PG&E Letter DCL-03-142

Docket No. 50-275, OL-DPR-80
Docket No. 50-323, OL-DPR-82
Diablo Canyon Units 1 and 2
Response to NRC Request for Additional Information Regarding License
Amendment Request 03-06, "Revision to Technical Specification 3.8.1,
'AC Sources - Operating'"

**PG&E Response to NRC Request for Additional Information Regarding License
Amendment Request 03-06, "Revision to Technical Specification 3.8.1,
'AC Sources - Operating'"**

Figure 1

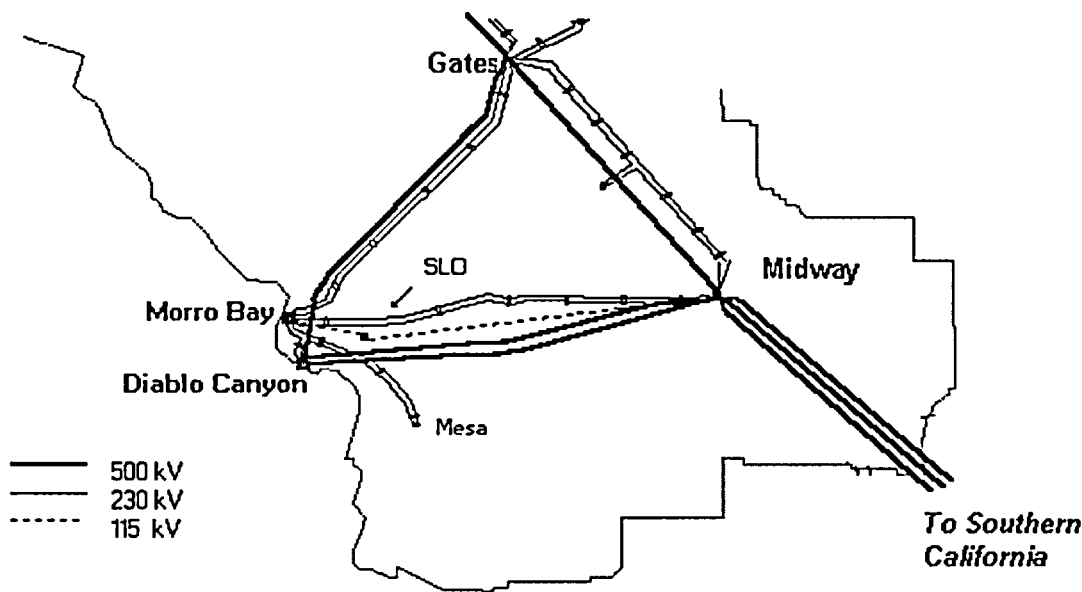
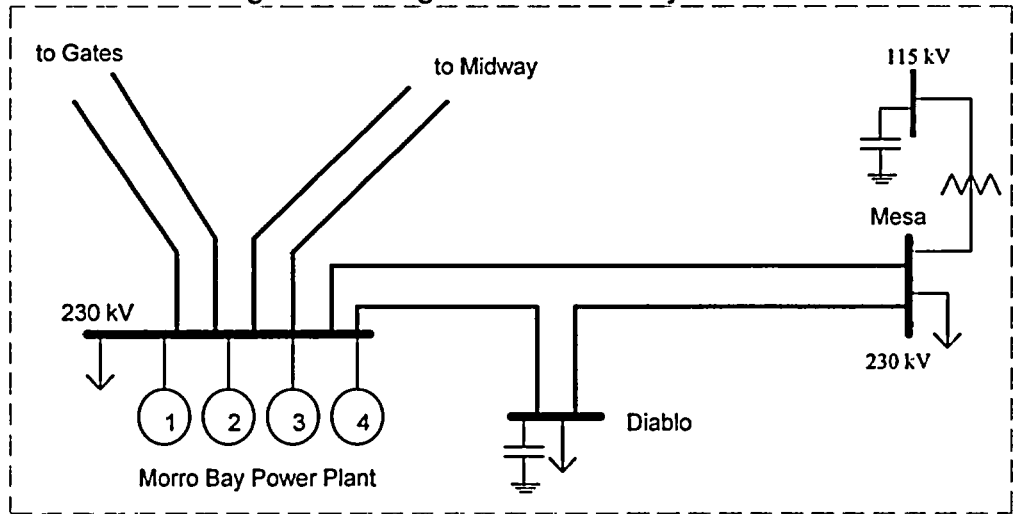
Discuss and provide information on the reliability and availability of offsite power sources relating to the proposed change. The discussion should include duration, cause, date and time of each loss-of-offsite power (partial or complete) event. In addition, discuss the current reliability of all DGs at Diablo Canyon.

The Oregon event discussed above occurred on August 10, 1996, and caused a 500 kV system transient that resulted in both DCPD units tripping off-line. However, the 230 kV system was available to safely shutdown the units. Subsequent to the 1996 event, PG&E installed generator out-of-step protection for each unit. The purpose is to protect the turbine-generator during severe grid transients. This protective function increases the likelihood of tripping the units and transferring to the 230 kV system during severe grid transients. However, the 230 kV and 500 kV switchyards are not inter-connected at DCPD. Consequently the loss of DCPD generation has negligible impact on the 230 kV voltage.
